SERVICE BULLETIN

REFERENCE BODY
NUMBER 039
DATE 09-14-90
MODEL '91 SW

1991 MR2 FUEL DOOR

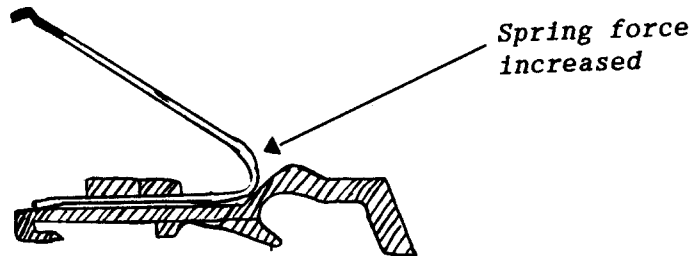
To improve fuel door opening, the spring force of the door hinge spring has been increased.

Note: Part number for the spring (PN 77360-17010) has not been changed.
